TIOGA DOWNS RACETRACK, LLC

Exhibit VIII.C.17.a.

Tioga Downs Racetrack Water and Sewer Systems Engineering Report

Tioga Downs Racetrack, LLC
Town of Nichols
Tioga County, New York

PROJECT NUMBER 516R16
DRAWING NUMBER R-1

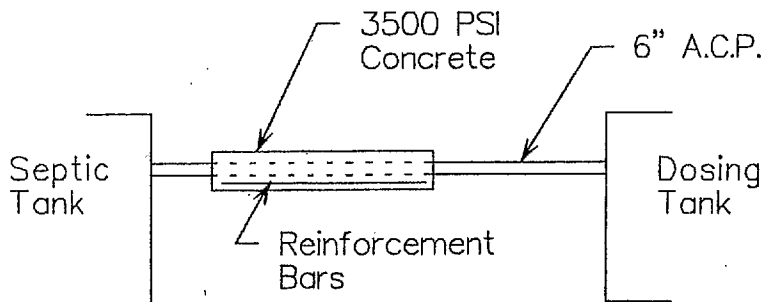
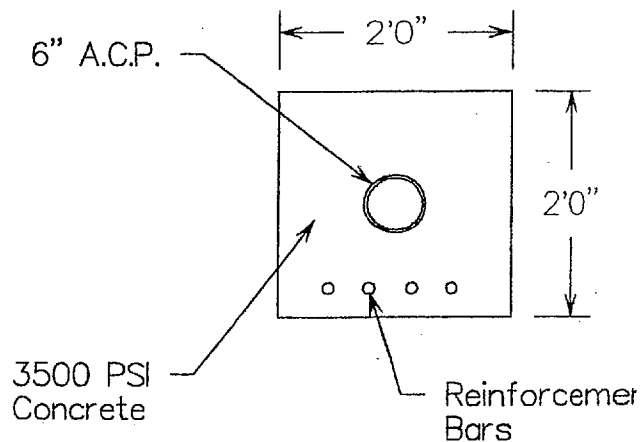
The pipe was repaired on June 5, 1996, by encasing the broken section of pipe in 3500 psi concrete as shown on attached Drawing #R-1. Some of the material below the pipe was removed and replaced with compacted material. The repair of the pipe with concrete was chosen to patch the leak in the pipe, provide additional strength to the pipe and avoid a major disturbance to the existing system if new lengths of pipe were installed. Also, since the existing pipe contains asbestos, replacement pieces are very difficult to find.

PROJECT NUMBER 516R16
R-1
DRAWING NUMBER

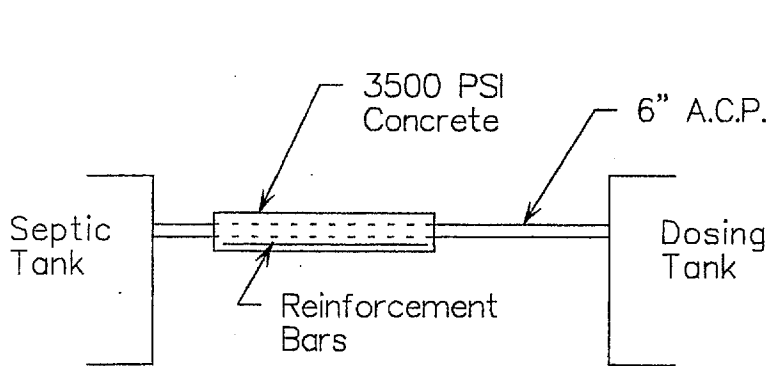
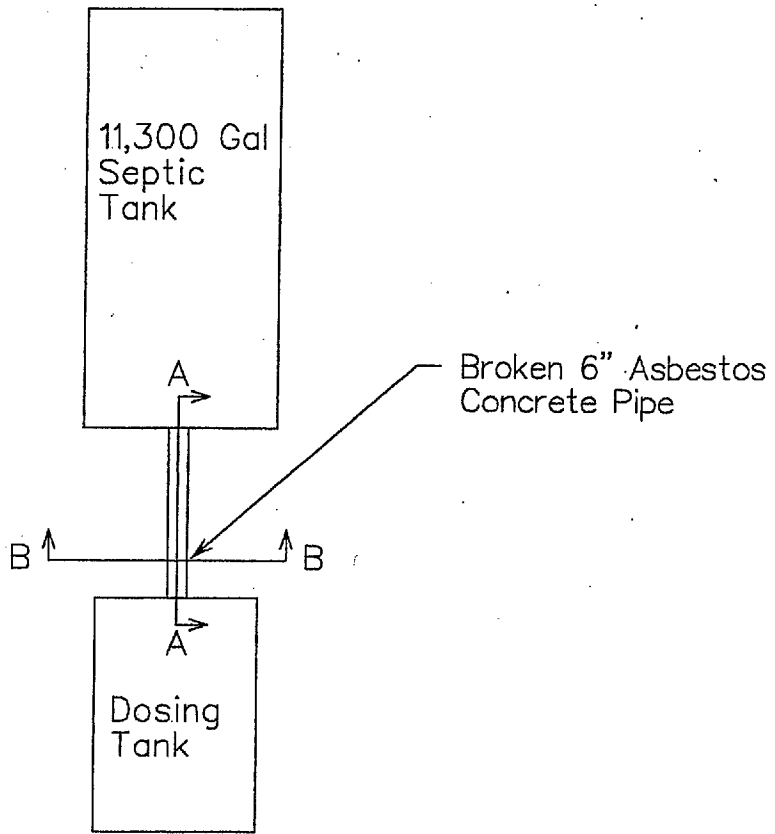
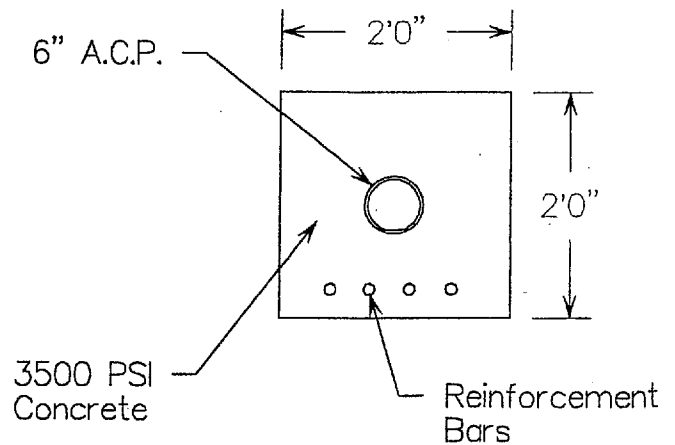
The pipe was repaired on June 5, 1996, by encasing the broken section of pipe in 3500 psi concrete as shown on attached Drawing #R-1. Some of the materials below the pipe were removed and replaced with compacted material. The repair of the pipe with concrete was chosen to patch the leak in the pipe, provide additional strength to the pipe and avoid a major disturbance to the existing system if new lengths of pipe were installed. Also, since the existing pipe contains asbestos, replacement pipes are very difficult to find.

Existing Monitoring Wells Map
7/2/96

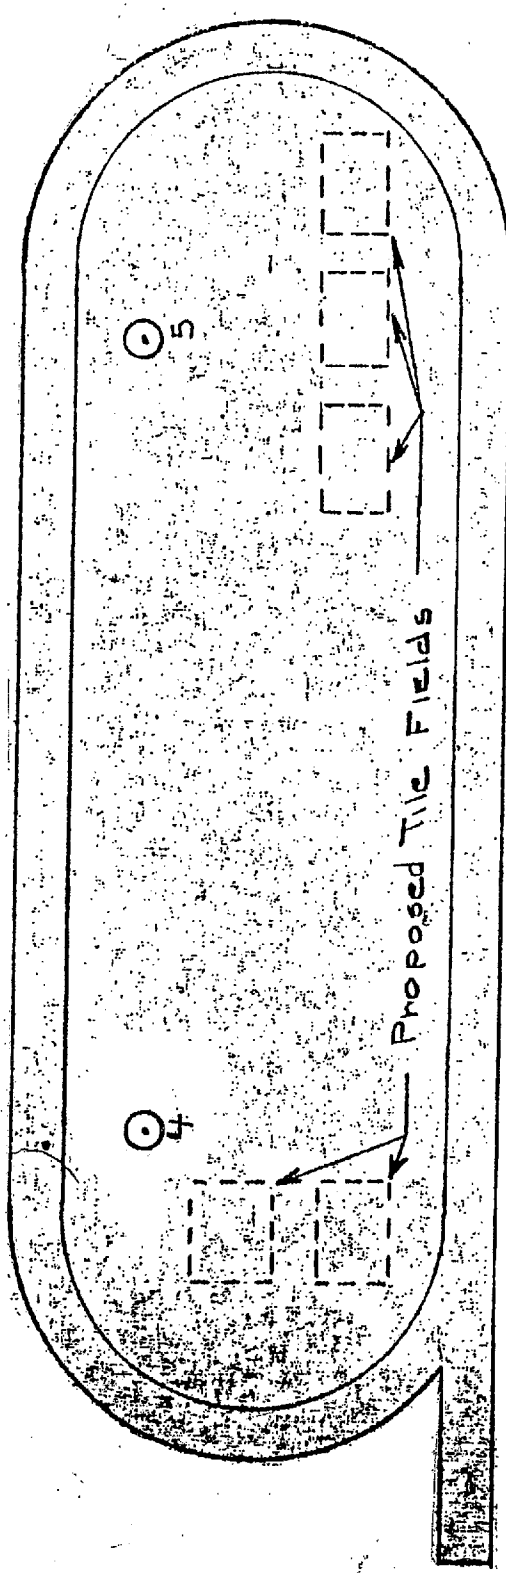
5. The original SPDES permit for this facility had a set of special conditions attached to it concerning 6 groundwater monitoring wells and the required sampling of the wells. Please provide the locations and working conditions of the monitoring wells on a site map or plans. This facility will be required by its SPDES permit to do groundwater sampling and monitoring. The reasoning behind this monitoring is to protect the groundwater and local drinking water supplies from Bacteria and Nitrate contamination. Both of these parameters are major health concerns for drinking water supplies originating from groundwater sources.

monitoring for Bacteria and Nitrates at the six indicated locations. We respectfully request that there be a one year time limitation on groundwater monitoring. If all water samples show a permissible level of these substances during the one year timeframe, we request that further monitoring be omitted from the SPDES permit requirements.
